Natural Environment Referral Response - Flood

Application Number:	DA2022/0145
Date:	31/05/2022
To:	Adam Susko
Land to be developed (Address):	Lot CP SP 32072 , 812 Pittwater Road DEE WHY NSW 2099 Lot CP SP 32071 , 4 Delmar Parade DEE WHY NSW 2099

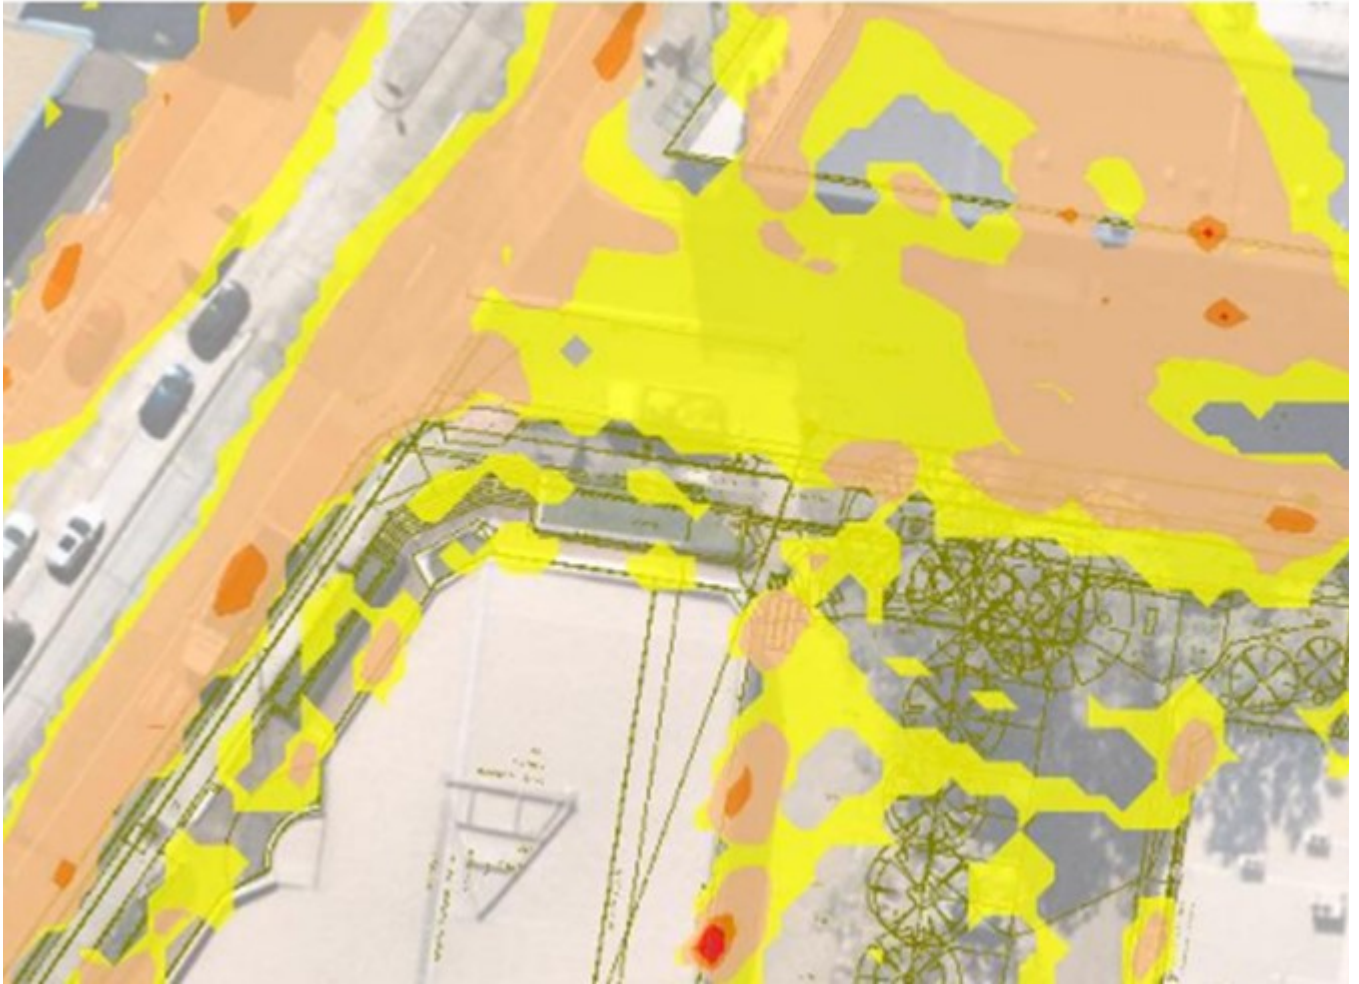
Irrespective of this, it is clear from the results provided, that by collecting and conveying the entire overland flow to a single discharge point in Delmar Parade has exacerbated existing flood behaviour at various locations, e.g flood depths increased by at least 0.1m and velocity x depth now has increased to above 0.4 etc See figures below. This resulted increased flood risks to existing properties and road users in Delmar Parade, Accordingly, does not comply with item A1 of section B3.11 of DCP.

- a. Submit sufficient information in quantity and clarity that will enable accurate, detailed assessment of the likely flood impacts to upstream, neighbouring and downstream properties. It is suggested that flood maps should show information on the differences between pre and post development conditions for a range of flood behaviour characteristics, including life hazards parameters etc.
- b. Amended flood report must assess and demonstrate clearly the proposal will satisfy all criteria as specified under section B3.11 of DCP.
- c. Revised architectural plans are to be submitted, clearly showing in plan view, long and cross-sections of proposed flood path, including design invert and top of retaining walls levels etc.
